DEVELOPMENT REVIEW COMMITTEE

CASE COMMENT REPORT

CASE NO. UDP-S24073

CASE	UDP-S24073
PROJECT NAME	315 NE 3 rd Street
APPLICATION TYPE	Site Plan Level II
APPROVAL LEVEL	City Commission Approval
REQUEST	Design Deviation Request to Increase Podium Height and Reduce Tower Separation for 607 Multifamily Units and 3,727 Square Feet of Commercial Use and Affordable Housing Density Incentive Requests in the Downtown Regional Activity Center
APPLICANT	Arosa Developers, LLC.
AGENT	Stephanie Toothaker, Esq.
PROPERTY ADDRESS	401 NE 2 nd Street
ABBREVIATED LEGAL DESCRIPTION	Geo M Phippens Subdivision B-146 D A Por Of Lots 13 Thru 16 Blk B
ZONING DISTRICT	Regional Activity Center – City Center (RAC-CC)
LAND USE	Downtown Regional Activity Center
COMMISSION DISTRICT	2 - Steven Glassman
NEIGHBORHOOD ASSOCIATION	Flagler Village Civic Association
SUBMITTAL	December 13, 2024
COMPLETENESS ISSUED	December 18, 2024
EXPIRATION	June 16, 2025 (180 Days)
WAIVER	Not Requested
CASE PLANNER	Yvonne Redding, Urban Planner III

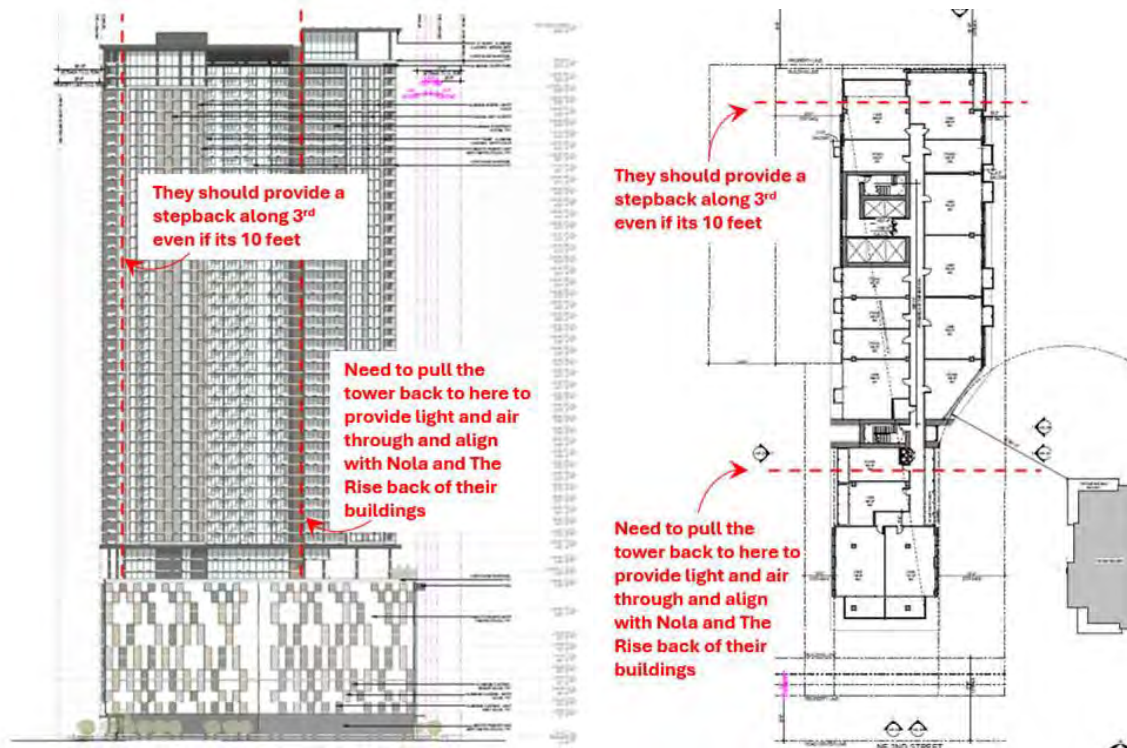
- 8) As proposed, the building is significantly larger in size and scale than the immediate surroundings. The overall development program is excessive given the size of the parcel, which is only exacerbated with the requested deviations, and results in a project that is not compatible with the surrounding built environment including recent developments. Furthermore, the applicant has not demonstrated that the proposed deviations meet the design intent for the applicable design element. The applicant should address the following: (1) ground level design, (2) architectural podium design, and (3) adjust tower placement. Below is a summary of each item above along with examples images. More detailed information is also provided throughout the planning comments.

- (1) *Ground level design.* It is the intent of the DMP to provide higher floor to ceiling heights, especially on the ground floor, to enhance the overall public realm experience. The portions of the building facing primary and secondary streets should have taller ceiling heights to create dramatic and elegant building forms with a compelling street presence and sense of arrival. In addition, the DMP encourages richer material palettes, more intensive details and lighting for the street level, and high-quality durable exterior materials. A rich layering of architectural elements throughout the building, with special attention to the ground floor and podium façade need to be provided. See images.

- (2) *Architectural podium design.* The additional podium height to accommodate stacked parking or storage of equipment exceed the maximum number of floors for the podium, which factors into the overall building height, and lacks mitigation for the additional podium height. Higher floor to ceiling heights, especially on the ground floor, enhance the overall public realm experience and use of mezzanines mitigate the impact. *Note:* Stacking or additional floor area such as mezzanine levels will require Florida Building Code review and approval as well as a backup mechanical repair plan if stacked equipment fails. See images below.

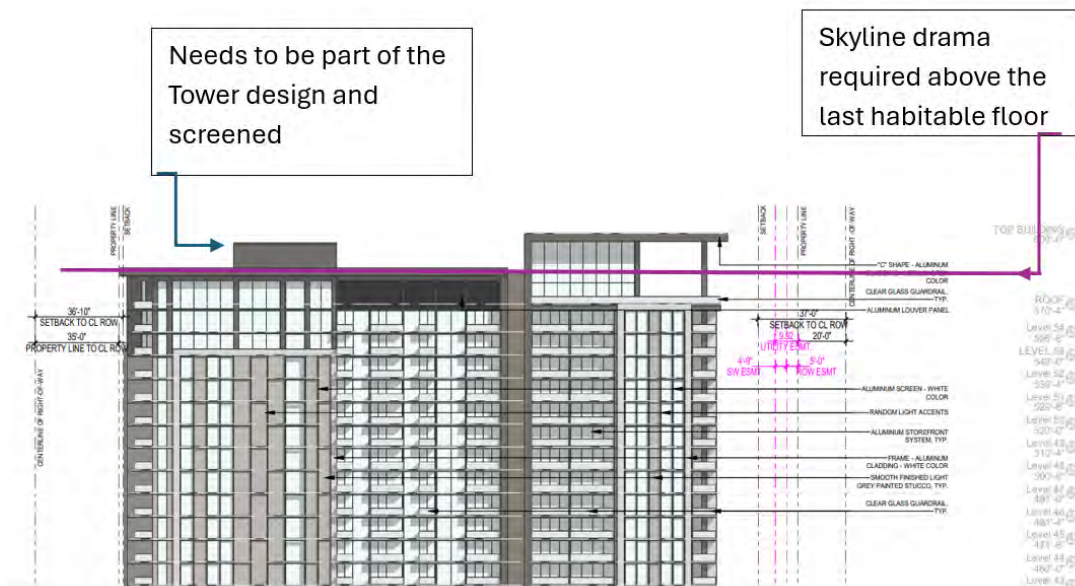
- a. Q-1, Provide skyline drama above last habitable floor. See images below.
- b. Q-2, Provide expressive tower top design that adds to the overall skyline. In addition, the roof top screening of equipment should be enhanced and incorporated into the tower top design. See images below
